## COUNCIL ASSESSMENT REPORT

Panel Reference	2018SNH053
DA Number	DA.296/18
LGA	North Sydney
Proposed Development	Integrated Development - Subdivision into 2 lots; demolition of existing buildings; construction of child care centre for 100 children; construction of new dwelling; landscaping and tree removal.
Street Address	12A Shirley Road, Wollstonecraft
Applicant/Owner	Mike and Shan Pty Ltd and Invas Investments Pty Ltd
Date of DA lodgement	13 September 2018
Number of Submissions	318 letters and petition with 140 signatures
Recommendation	Refusal
Regional Development Criteria (Schedule 7 of the SEPP (State and Regional Development) 2011	Capital Investment Value (CIV) exceeds \$5 Million - Community Facility
List of all relevant s4.15(1)(a) matters	<ul style="list-style-type: none"> <li>• Rural Fires Act 1997</li> <li>• State Environmental Planning Policy (Educational Establishments and Child Care Facilities) 2017</li> <li>• State Environmental Planning Policy No.55 Remediation of Land (SEPP 55)</li> <li>• Sydney Regional Environmental Plan (SREP) (Sydney Harbour Catchment) 2005</li> <li>• North Sydney Local Environmental Plan 2013</li> <li>• North Sydney Development Control Plan

Source: Tree Wise Men

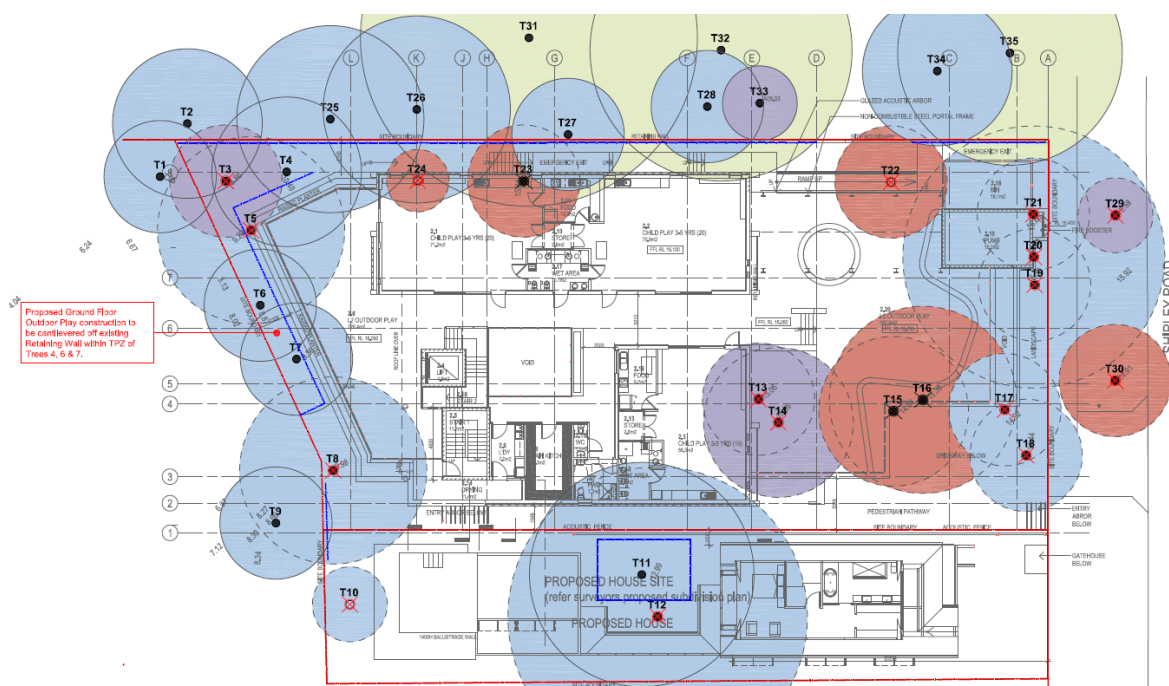
The proposal does not comply as Trees 5, 8, 10, 12, 13, 14, 17, 18, 19, 20 and 21 are proposed for removal due to construction impacts. The proposal does not retain trees that have been identified by the arborist as worthy of retention. The existing trees have therefore not informed the building footprint. An amended proposal should seek to retain trees identified by the arborist as being greater than 10 m in height and/or worthy of retention. Specifically, Tree Nos 5-Cheese Tree, 8 -Swamp She Oak, 20 -Willow Bottlebrush, 22-Lemon-scented Tea Tree, 24- Native Frangipani, 29 -Photinia Street

Tree and 30- Photinia Street Tree. The latter two trees are Council's assets and should be retained. In addition, canopy pruning of trees with the bushland area may have to occur to allow the development to proceed. This is not supported and is one of the reasons for a bushland buffer zone.

The species *Glochidion ferdinandi* (Cheese Tree) is believed to have poisonous fruit and may be an inappropriate species for a childcare centre. Adequate separation should be provided around the retained Cheese Trees on site and on the adjacent properties to ensure that there is an acceptable risk or evidence is to be presented that the Cheese trees does not present a risk to the children.
